<b>DOCKETED</b>	
<b>Docket Number:</b>	21-BSTD-01
<b>Project Title:</b>	2022 Energy Code Update Rulemaking
<b>TN #:</b>	238382
<b>Document Title:</b>	Jon McHugh Comments - Retain Stringency and Enforceability of Residential Lighting Standards
<b>Description:</b>	N/A
<b>Filer:</b>	System
<b>Organization:</b>	Jon McHugh
<b>Submitter Role:</b>	Public
<b>Submission Date:</b>	6/21/2021 4:22:33 PM
<b>Docketed Date:</b>	6/21/2021

**Retain Stringency and Enforceability of Residential Lighting Standards**

**Re: 21-BSTD-01 2022 Energy Code Update Rulemaking**

**Recommendation to reverse the changes to Sections 150.0(k)1B, 160.5(a)1B and Tables 150.0-A and 160.5-and support quality residential lighting**

Figure 1: JA8 MAEDBS database: Number of Unique Models by Light Source Type

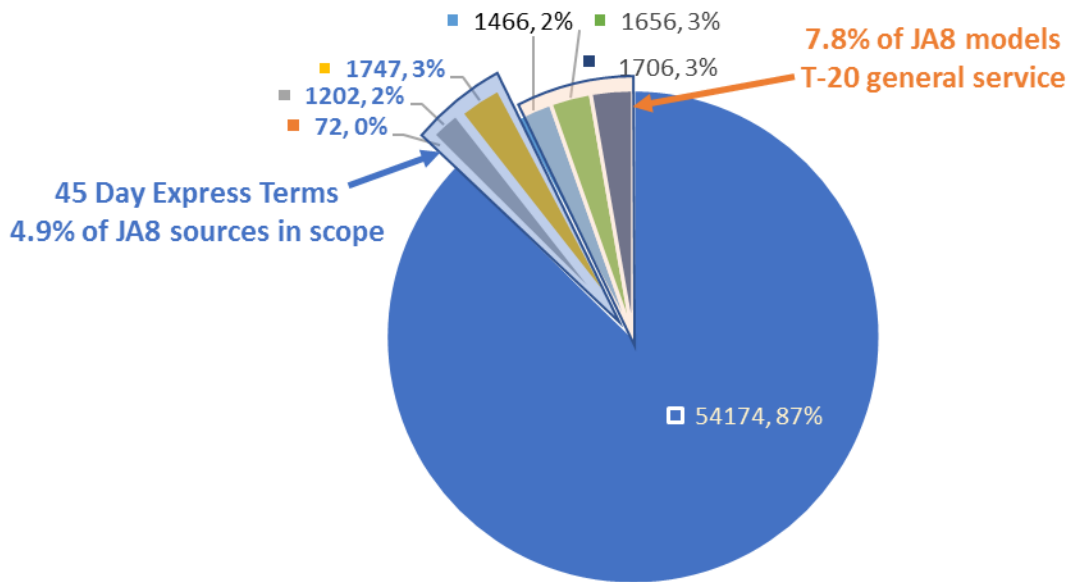
As shown in Figure 1, the exceptions for inseparable solid state lighting sources and general service LED lamps would reduce the number of JA8 covered models to only 4.9% of models currently in the JA8 database. Some fraction of the remaining 4.9% LED sources (small diameter directional lighting, decorative lights, light engines and strip lights) would also be exempted for having color tuning or dim to warm controls.

The ease of enforcing the current JA8 requirements result from their simplicity: every indoor LED that is capable of producing white light shall have the JA8 label. Under the proposed changes, this simple enforcement rule will be no longer valid; only 4.9% of the number of models in the current JA8 database would be required to have the JA8 mark.

Figure 3: JA8 flicker data (cut-off frequency 200 Hz) for T-20 general service lamps, with green overlay for IEEE-1789 “no risk” and yellow overlay for “low risk” regions

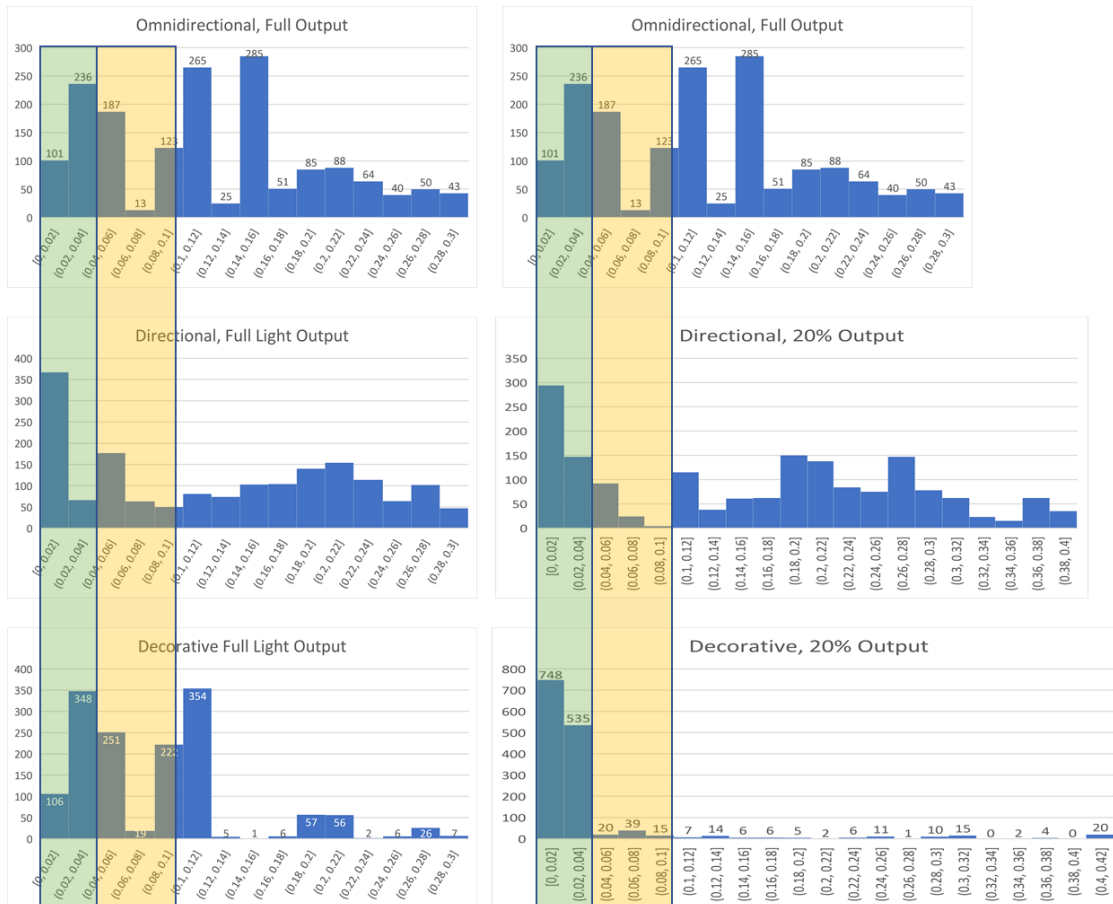
The data below from the JA8 database indicates there is a critical mass of lamps that would meet the IEEE 1789 standard but that there are still many lamps just below the 30% maximum flicker level that have flicker levels similar to magnetically ballasts fluorescents that were correlated with headaches.

The above information for Title 20 lamps (or any other source that is exempted from JA8) would be not accessible for the quickly changing market if the 45 Day Express terms does not reverse course of weakening the consumer protections for residential lighting and return to the 2019 Table 150.0-A requirements for JA8 coverage.
